FINAL DEVELOPMENT PLAN APPLICATION

CLAYCRAFT WAREHOUSE

Subject: Claycraft Warehouse- Final Development Plan Comments
City of Gahanna, Franklin County, Ohio
CEC Project 182-564

RE: Project 870 Claycraft Rd Final Development Plan Comments

DET. POND DETAIL

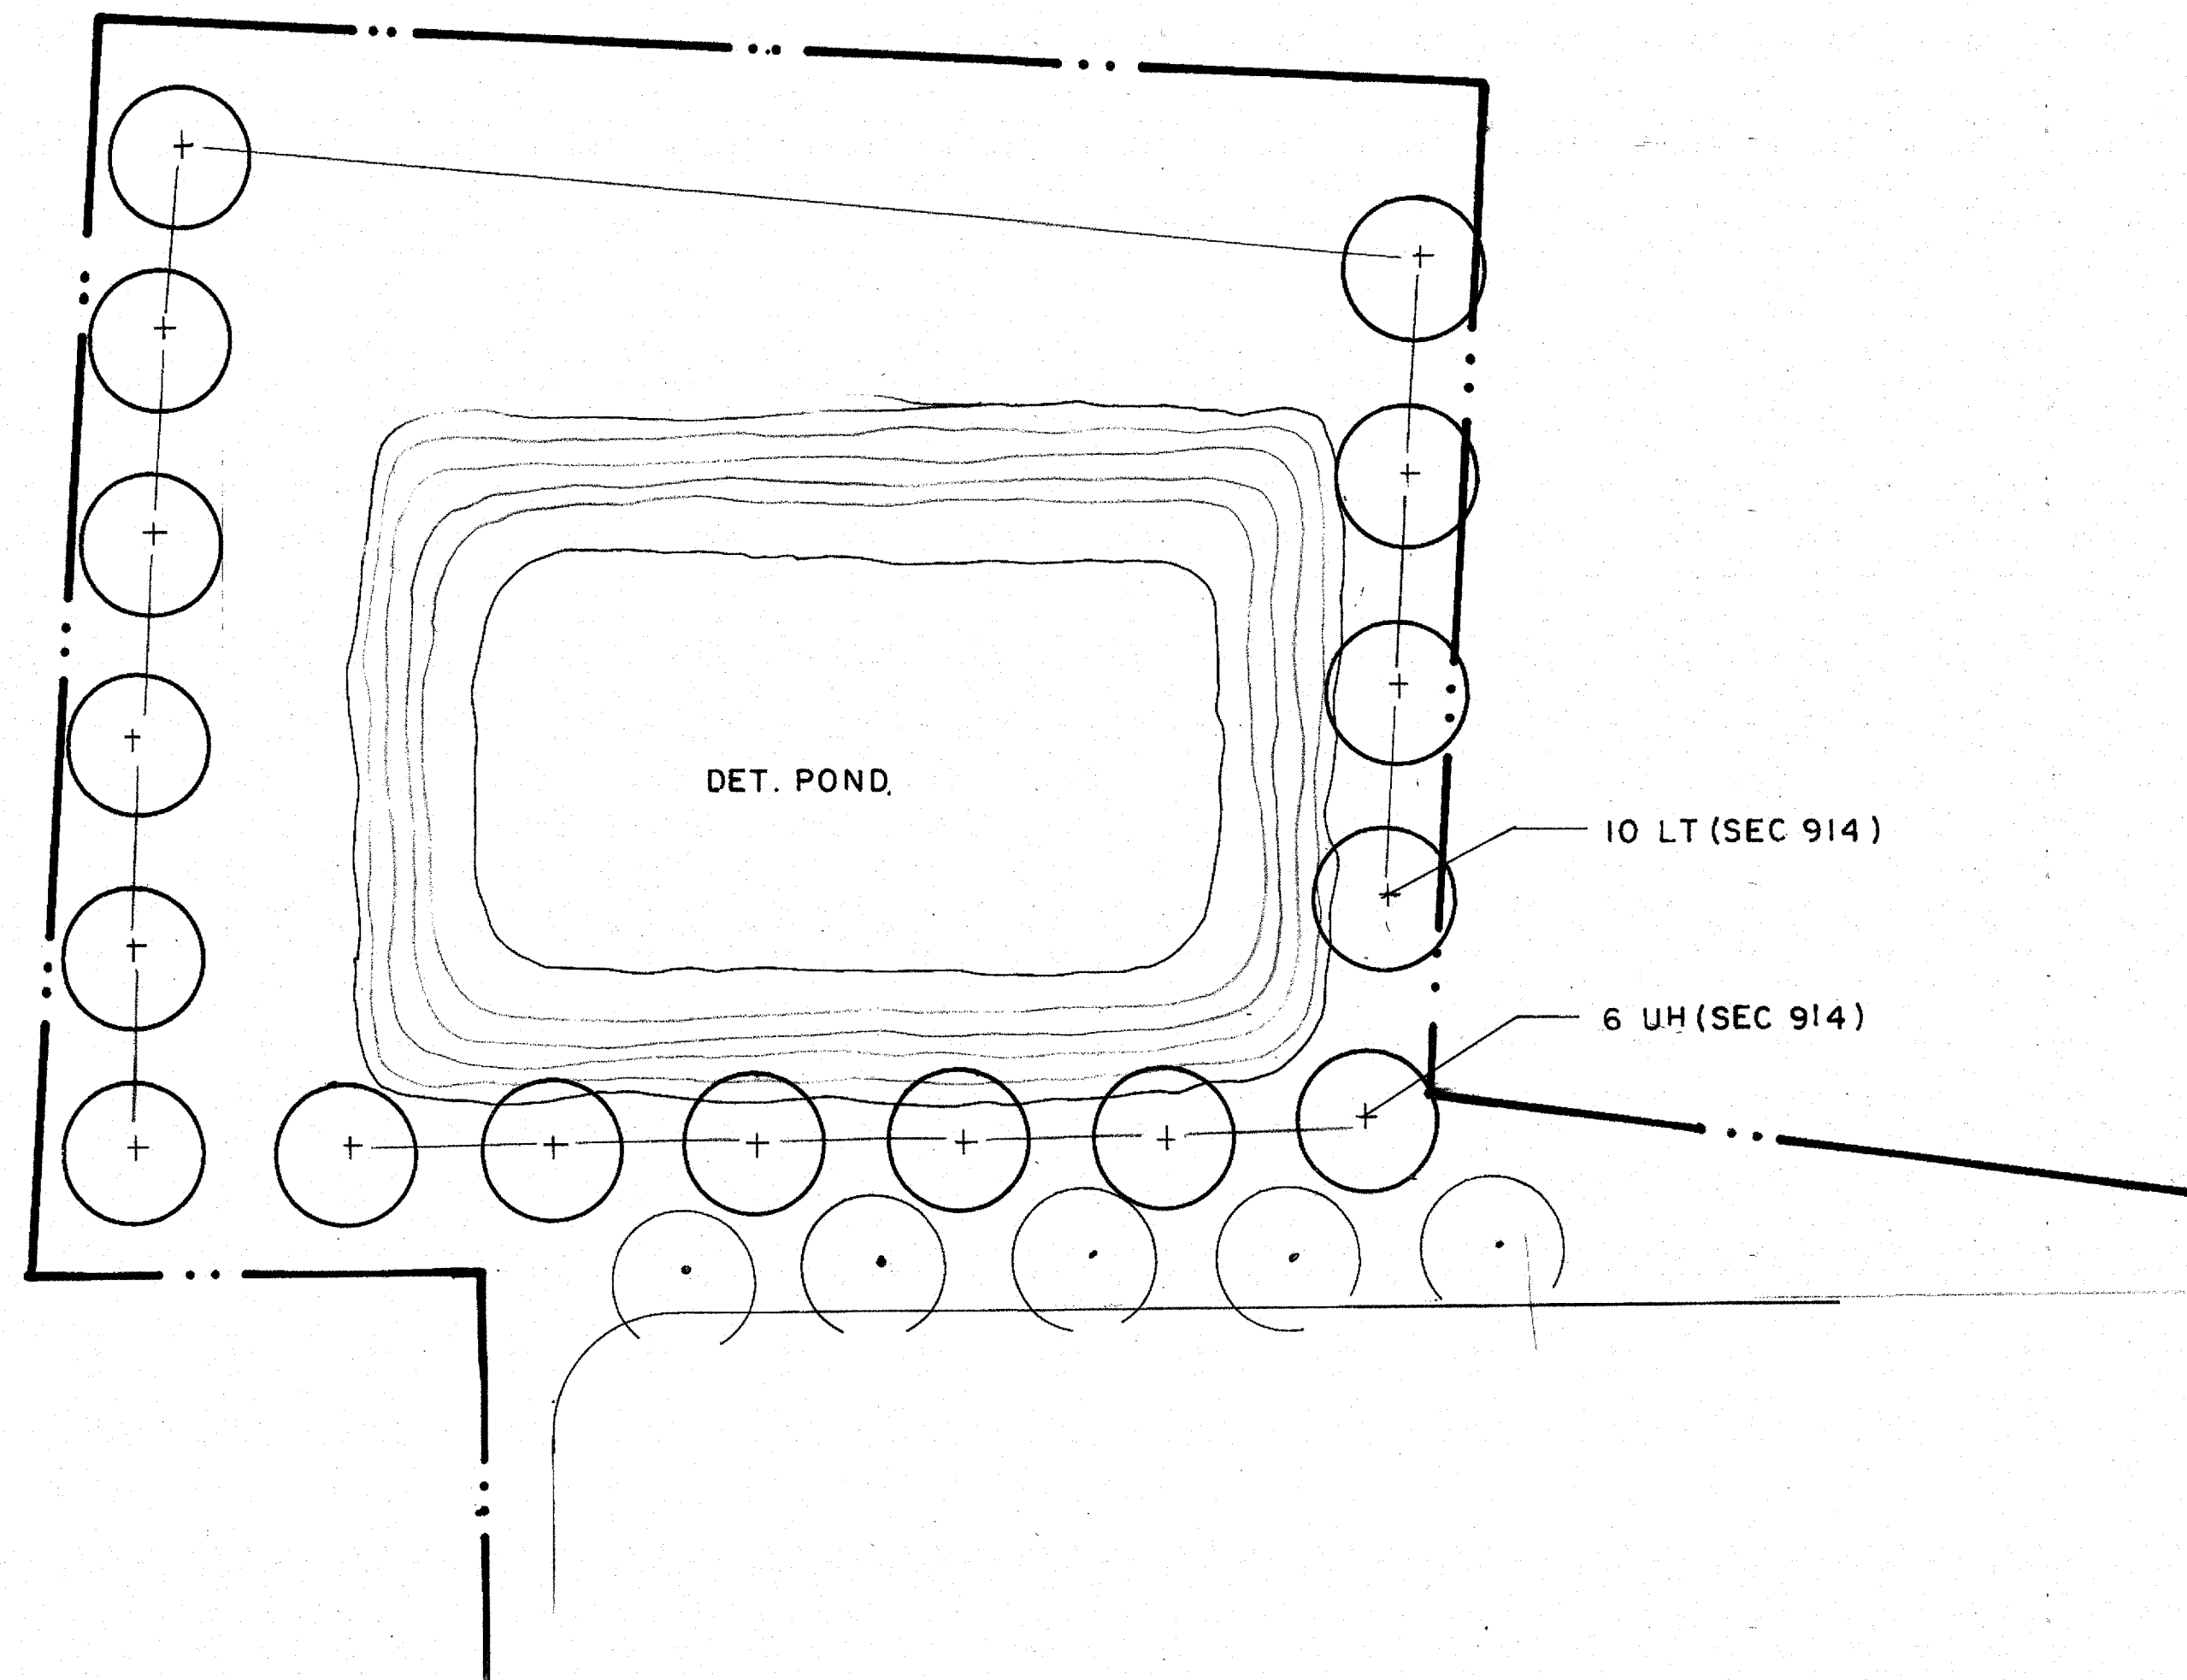
3. I only have one comment regarding 870 Claycraft. The proposed detention basin is in the path of the overflow from the adjacent pond. As shown, the detention basin will intercept the surface flow from the pond. The final design plan should address the emergency overflow from the offsite pond and potential impacts to their detention basin outlet.
OK as noted.
